SUBJECT: Forwards addl response to 820730, 0916 & 830810 requests for
 info on hydrogen combustion & control. Info covers capability
 of air return/hydrogen skimmer sys fan & ice condenser doors
 to survive differential pressure loadings

Donald C. Cook Nuclear Plant Unit Nos. 1 and 2
Docket Nos. 50-315 and 50-316
License Nos. DPR-58 and DPR-74
ADDITIONAL RESPONSES TO REQUESTS FOR INFORMATION ON
HYDROGEN COMBUSTION AND CONTROL

ATTACHMENT 1 TO AEP:NRC:0500M
RESPONSES TO QUESTIONS ON HYDROGEN CONTROL
CONTAINED IN MR. S. A. VARGA'S LETTER DATED AUGUST 10, 1983
DONALD C. COOK NUCLEAR PLANT UNIT NOS. 1 AND 2

Figure 1-1
D.C. COOK CLASIX MODEL

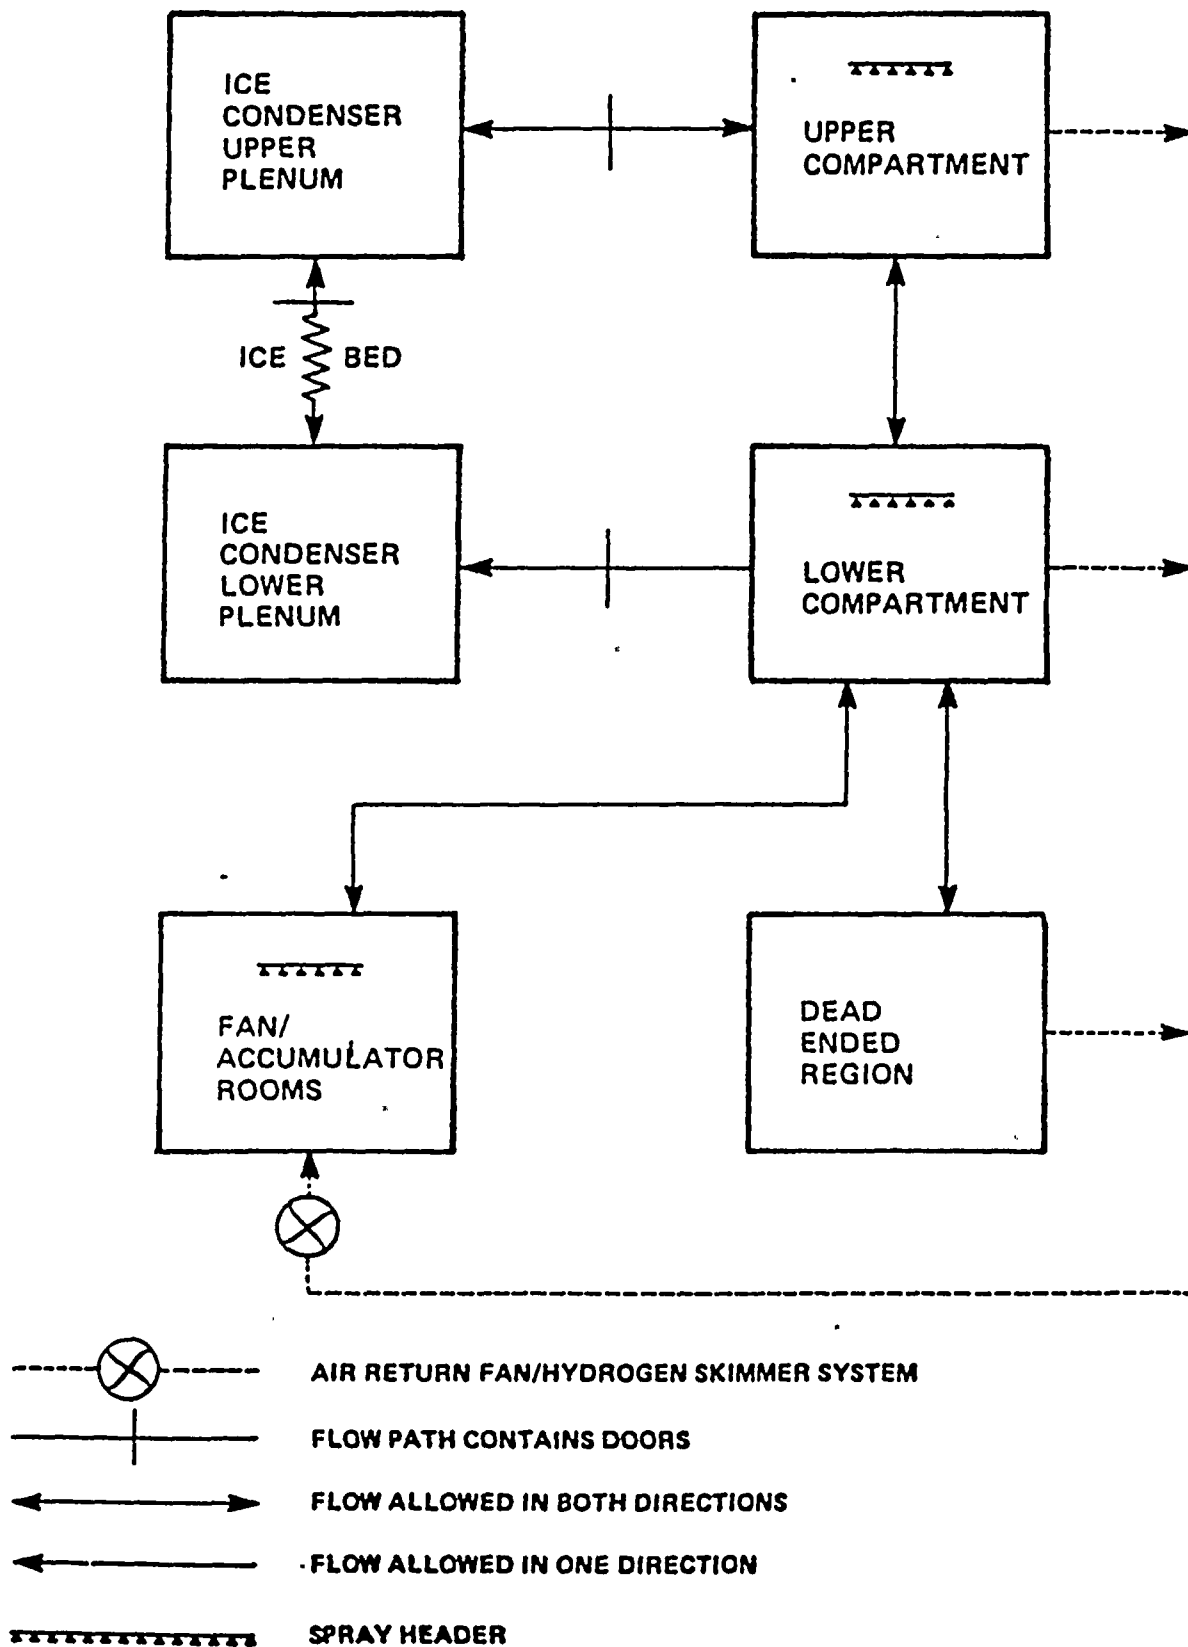
A schematic diagram of the CLASIX containment model for the Donald C. Cook Nuclear Plant is given in Figure 1-1. Each case was performed using the same input parameters as used for CLASIX Case "C" of Reference (1-2), except for the time step and passive heat sink nodalization. The time step was increased from 0.01 to 0.1 second to reduce computer run time. Due to this time step change, the number of nodes in appropriate wall layers were reduced to maintain stability. Passive heat sink data are given in Tables 1-1 through 1-8 and reflect the noding changes. Also, due to the slightly different pressure response obtained by using the Uchida correlation, the fan and spray initiation time increased since the 3.0 psig set point was reached later in the transient. The spray initiation time increased from 141 to 190 seconds, while the air return fan/hydrogen skimmer system initiation time increased from 711 to 760 seconds.

Figure 2-1. Spray mass vaporization during a CLASIX upper compartment burn.

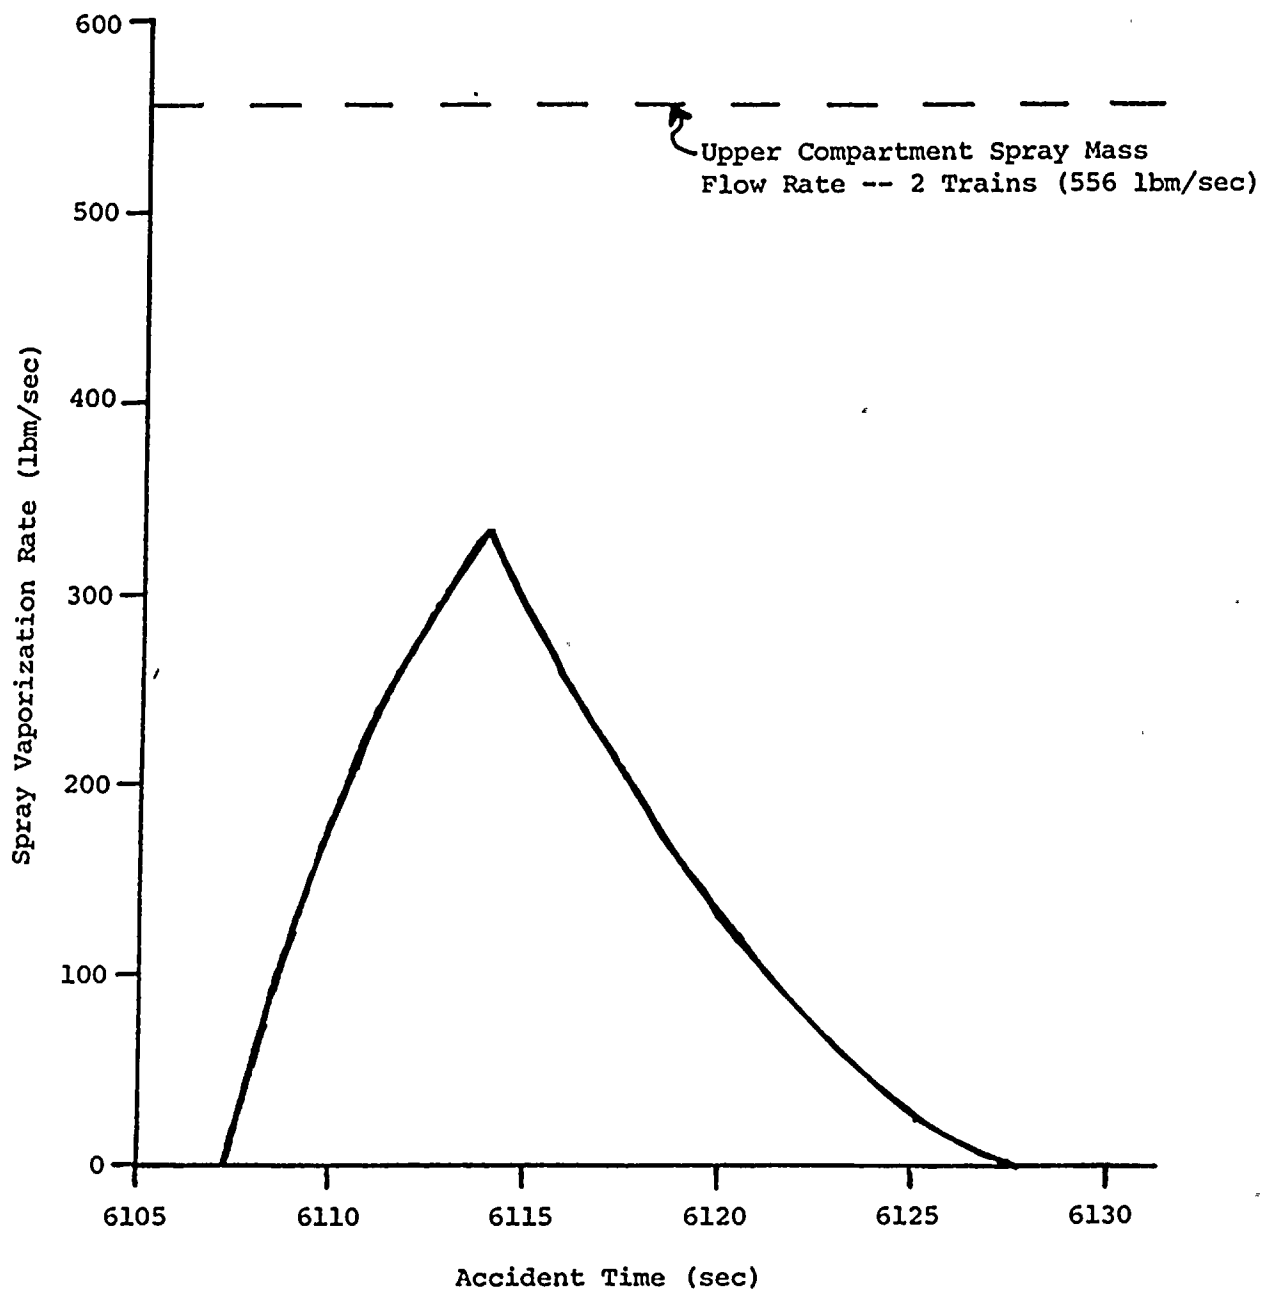
Based on a total spray mass flow rate of 556 lbm/sec for the Donald C. Cook Nuclear Plant upper compartment, the rate of spray mass vaporization has thus been calculated for this case. The values obtained from this analysis are presented in the last column of Table 2-1, and are plotted in Figure 2-1. The results indicate that a peak spray mass vaporization rate of 330 lbm/sec will be reached at the time of peak compartment temperature and pressure.
